ORIGINATION FORM

Proposed Revisions to a Standard Plans Index
(Please provide all information – Incomplete forms will be returned)

Index Number: 521-404
Sheet Number (s): 1
Index Title: Guardrail Transitions- Existing Post & Beam
Bridge Railings (Narrow & Recessed Curbs)

LAST REVISION 07/01/13	REVISION	DESCRIPTION:	 FY 2019-20 STANDARD PLANS	GUARDRAIL TRANSITIONS-EXISTING POST & BEAM BRIDGE RAILINGS (NARROW & RECESSED CURBS)	INDEX 521-404	SHEET 1 of 8
---------------------------	----------	--------------	---	---	-------------------------	------------------------

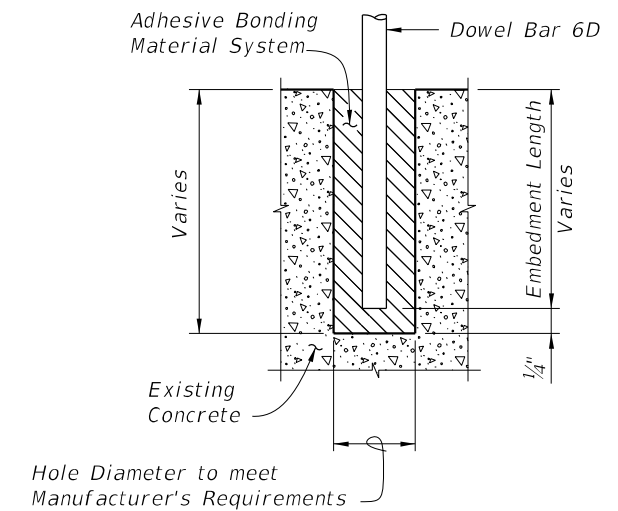
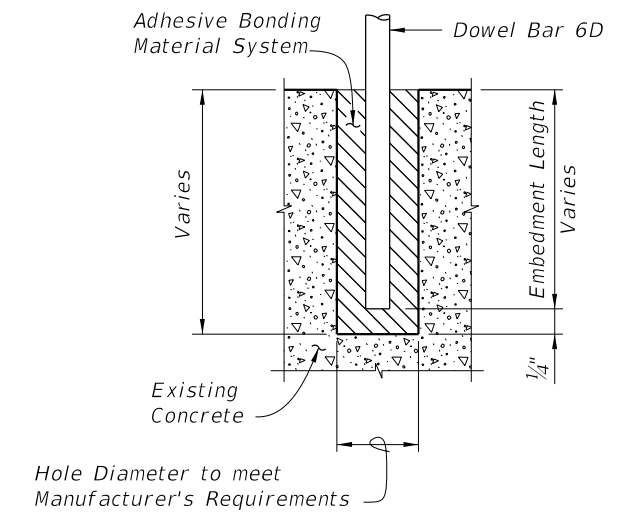
Changed Payment Note

Updated payment to match the BOE

PAYMENT: ~~Guardrail Bridge Anchorage Assembly (each) includes all barrier delineators for the entire bridge length, transition blocks, and necessary hardware to complete the Guardrail transitions shown.~~

Concrete Traffic Railing-Bridge Retrofit - Post & Beam Railing (EA) includes all material and labor required to demolish and portion of the existing structure where required and to construct the concrete portion of the retrofit railing. **Guardrail Approach Transition to rigid Barriers (EA)** includes transition block, and necessary hardware to complete the Guardrail transitions shown.

PAYMENT: Concrete Traffic Railing-Bridge Retrofit - Post & Beam Railing (EA) includes all material and labor required to demolish a portion of the existing structure where required and to construct the concrete portion of the retrofit railing. Guardrail Approach Transition to rigid Barriers (EA) includes transition block, and necessary hardware to complete the Guardrail transitions shown.
